APPROVED
 BY: TB
 DATE: 4/6/17
MADISON COUNTY ENGINEERING AND ROAD DEPARTMENT

SITE PLAN	
GATED ENTRANCE KATHERINE DRIVE	
LAKE CAROLINE / MADISON COUNTY, MS	
	MICHAEL GIBSON LANDSCAPE ARCHITECT, INC. P.O. BOX 31 MADISON, MS 39130 601 583 3323 <small>MSB00001-REPLACEMENT PLANET B # 182426-004</small>
L1	3/31/17 030117

PROPOSED GATE SITE PLAN
 SCALE: 1" = 10'-0"

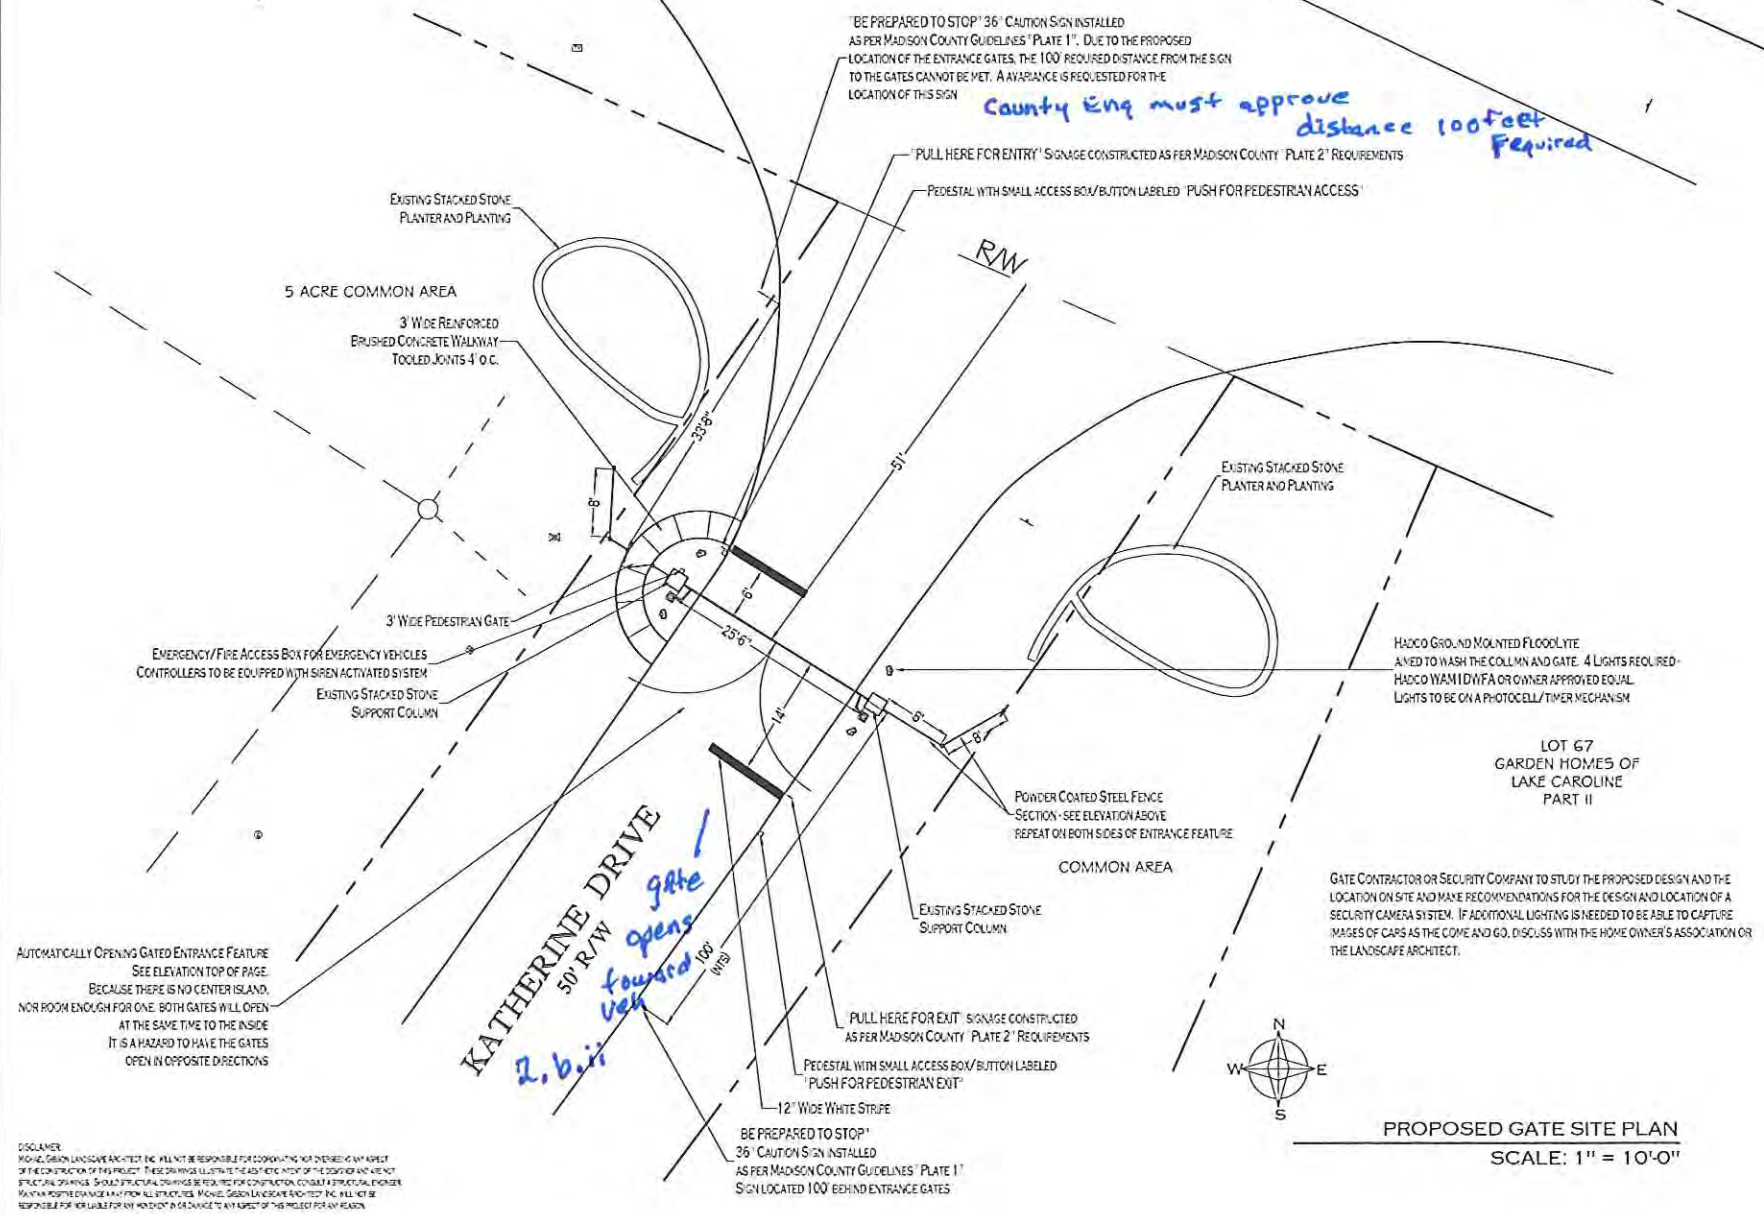
provide color renderings for approval

VARIANCE FOR SB W/ 3-4 TO LESS THAN 100' FROM GATE IS APPROVED
